August 14, 2014

**Re: City of Warrenton (PWS ID #00932) Lake View Rd 6-in Watermain Extension
Conditional Approval - PR #118-2014**

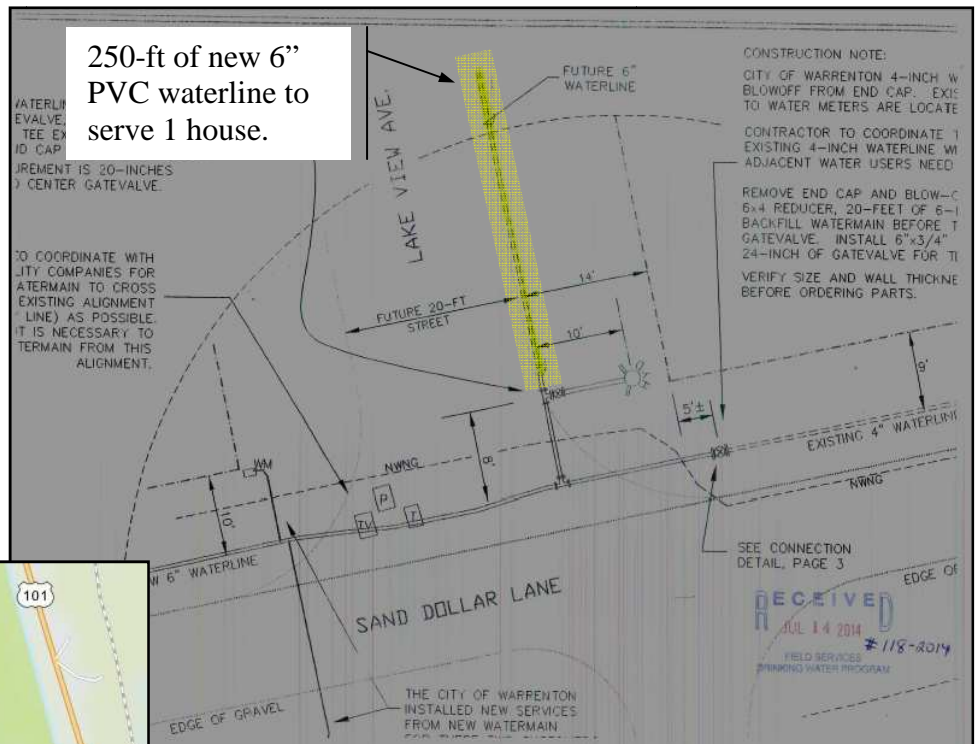
I have completed my review of the submitted plans (received July 14, 2014 along with a check for \$600 and a Land Use Compatibility Statement) for the construction of a potable waterline for the *Lakeview Ave 6-inch Watermain Extension* project in the vicinity of Lake View Road and Sand Dollar Lane near Warrenton, Oregon (PR #118-2014). The waterline extension calls for the installation of roughly 250-ft of 6" PVC main within public ROW of Lake View Rd. highlighted in the project plan shown at right.

The project is approved for construction as shown in the submitted plans, provided the following conditions are met:

1. Waterlines are designed for potable use meeting NSF-61 standards and installed and tested in conformance with the latest standards of the American Water Works Association, NSF International, or other equivalent standards with at least 30 inches of cover and disinfected and tested according to the latest AWWA standard C651.

2. The design ensures 20 psi to be maintained at all service meters.
3. Air-relief valves are installed at high points where air could accumulate in such a manner that the breather tube extends above ground and is provided with a screened, downward facing elbow.

4. Dead ends are minimized by looping. Where dead ends are installed, or low points exist, blow-offs of adequate size are provided for flushing.
5. Provisions are made at all bends, tees, plugs, and hydrants to prevent movement of the pipe or fitting.

6. Number 18 AWG (minimum) solid copper tracer wire is installed according to OAR 333-061-0050(8)(k), with wire ends accessible in water meter boxes, valve boxes, or outside the foundation of buildings where the pipeline enters the building. It is recommended that the tracer wire be placed immediately above the initial backfill material and directly over the pipe according to the latest AWWA Standard C605 *Underground Installation of PVC Pipe*.

7. No sewer lines are anticipated in the project area, however, if they are encountered or planned, the waterline meets all installation requirements of OAR 333-061-0050(9) in relation to sanitary sewer mains and laterals. Where the lines cross, a minimum vertical separation of 1.5-ft or more between the top of the sewer line and the bottom of the waterline should be used with one full length of the waterline centered at the sewer crossing. Where a waterline runs parallel with a sewer line, the horizontal separation between the lines should be 10-ft (or 5-ft with the 1.5-ft vertical separation as described above).
